#02-06-04-037F: DTC P0446 (Restricted/Blocked EVAP Vent Path) Set, Check Engine Light On (Replace Evaporative Emission (EVAP) Vent Valve Solenoid Assembly and Add/Relocate Filter Box Using Service Kit) - (Aug 5, 2009)

This bulletin is being revised to provide an updated picture of the remote filter box and to add an important statement to not replace the EVAP canister. Please discard Corporate Bulletin Number 02-06-04-037E (Section 06 -- Engine/Propulsion System).

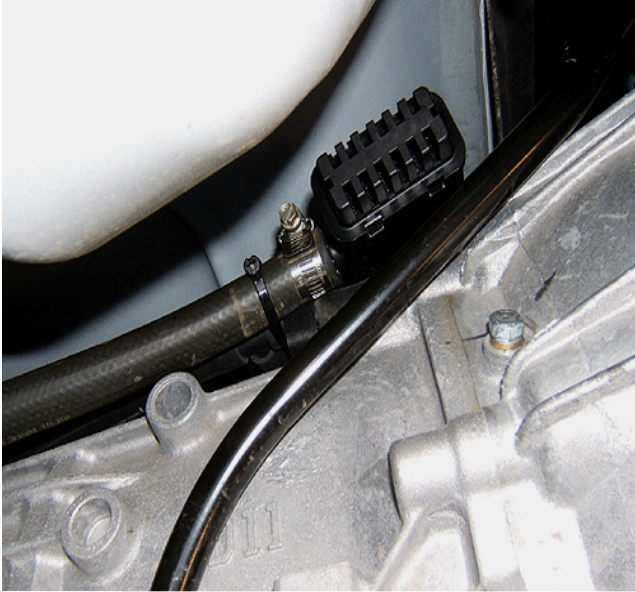
Important: The new canister vent valve will be installed in a new location, outside of the frame.

- Position and secure the new valve assembly to the frame bracket on the outside of the frame using the existing hole and mounting bolt.

Tighten the bracket mounting bolt to 12 N·m (106 lb in).

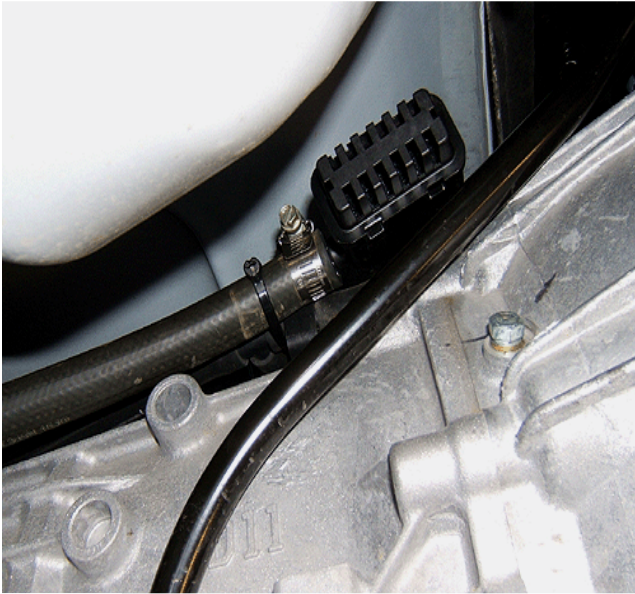
- Secure the filter box to the transmission vent hose just forward of the hose tee-section using a tie strap. DO NOT pinch or restrict the transmission vent hose. The filter box opening should be pointing downward.
- Raise the transmission and reinstall the transmission support.
- Tie strap the hose as needed along the frame rail in order to keep the hose away from pinch-points and heat sources.
- Lower the vehicle.
